**RE: Addendum #4  
RFP 19-33 Steelfield Road Landfill Expansion Project Design Build  
Team**

**STEELFIELD ROAD LANDFILL EXPANSION**

**CELL CONSTRUCTION DETAILS (SHEET 1 OF 5)**

**MODIFICATION TO EXISTING LEACHATE TRANSMISSION SYSTEM: PLAN AND PROFILE (SHEET 1 OF 2)**

**BOTTOM LINER SYSTEM** 1  
 000-01  
 NOT TO SCALE

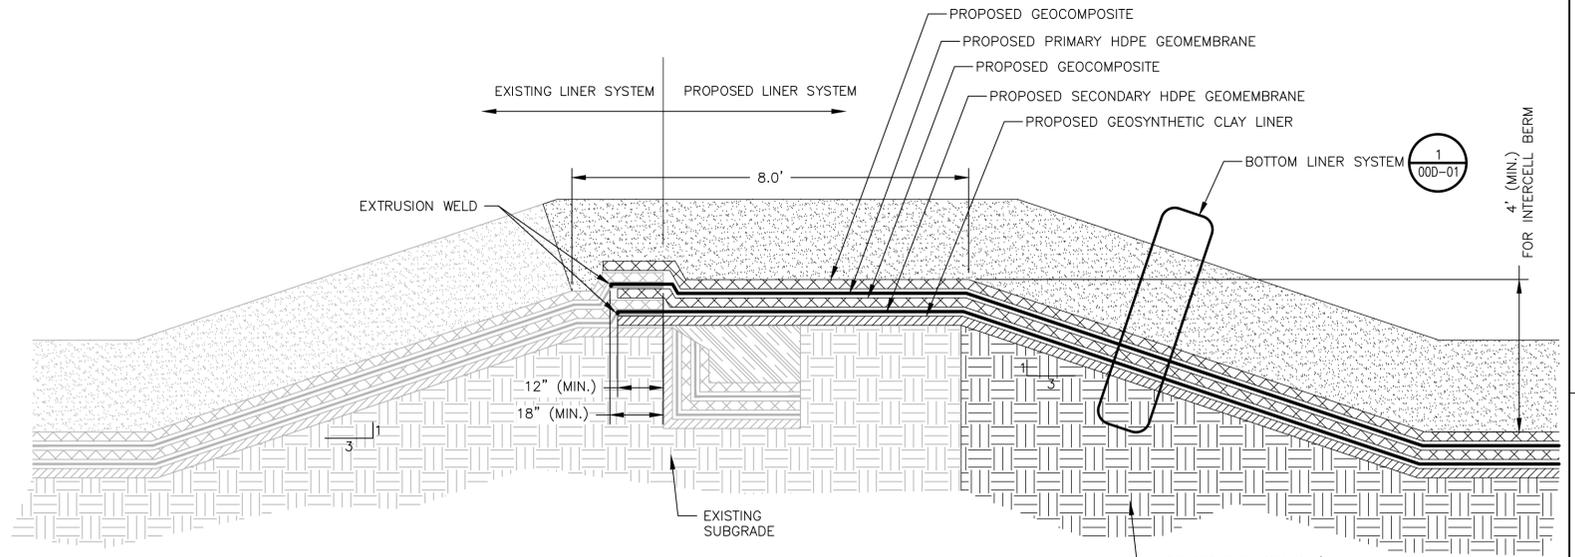
Detail 1

A minimum of 2-foot structural fill thickness is required below the geosynthetic liner components within the limits of Cells 1 and 2 vertical expansion. A minimum 1-foot thickness shown in the drawing set issued with Addendum #2 is a typo.

In addition specification Section 02300 Part 3.4 F, items 3 and 4 should be revised to maintain minimum 2-foot soil cover below the liner.

**INTRACELL BERM** 5  
 000-04  
 NOT TO SCALE

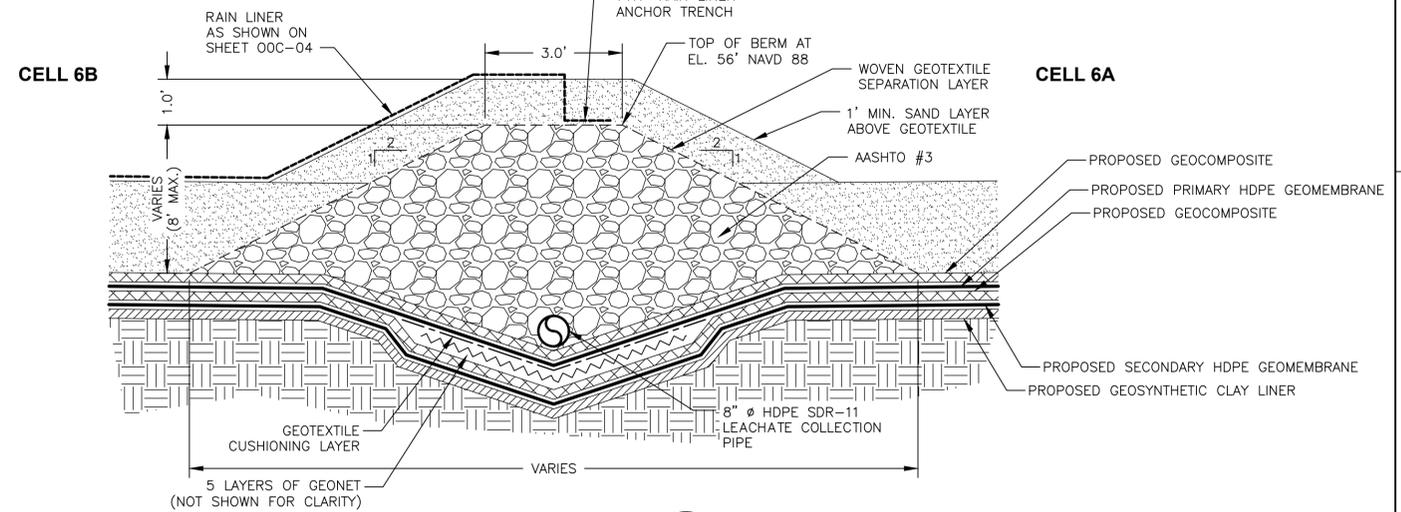
Detail 5

The maximum expected height of the gravel berm dividing Cells 6A and 6B is 8 feet. The 14-foot maximum height shown in the drawing set issued with Addendum #2 is a typo.

FILENAME | 01C-01.dwg  
SCALE | AS SHOWN  
SHEET | 01C-01

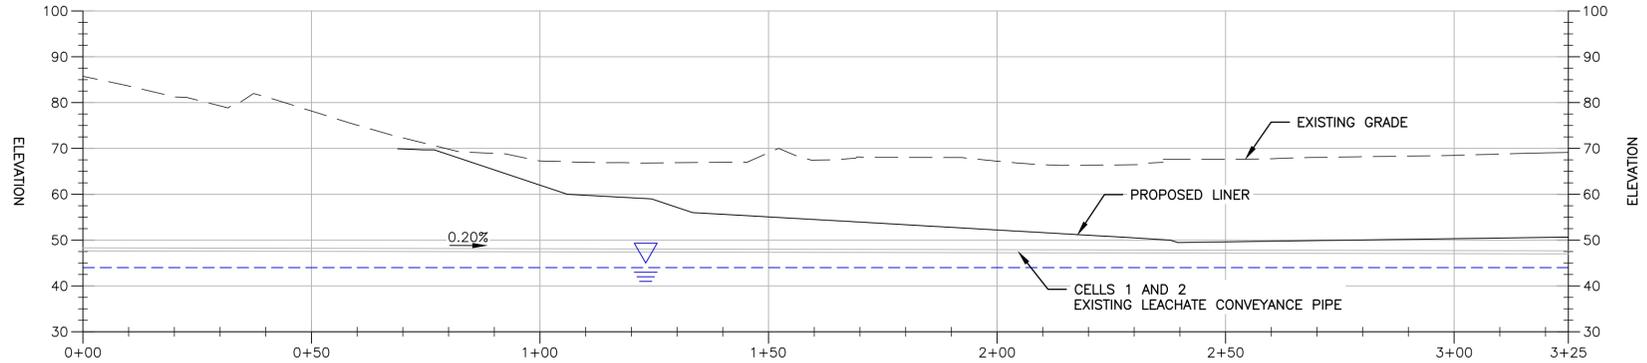
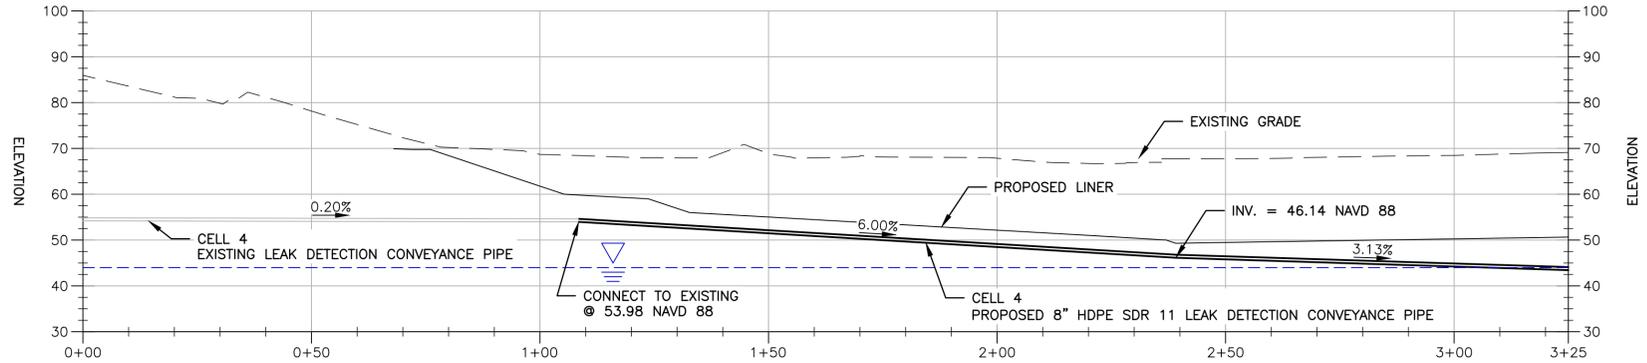
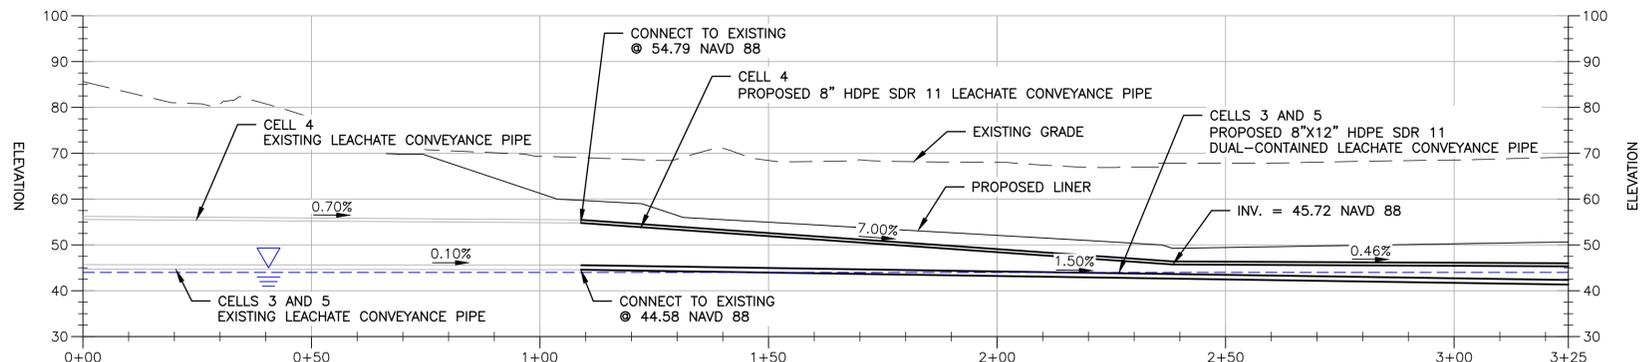
Profile C

Approximate groundwater elevation in Profile C is incorrectly shown in the drawing set issued with Addendum #2. It is now adjusted to show approximately 44 ft NAVD in the area concerned.
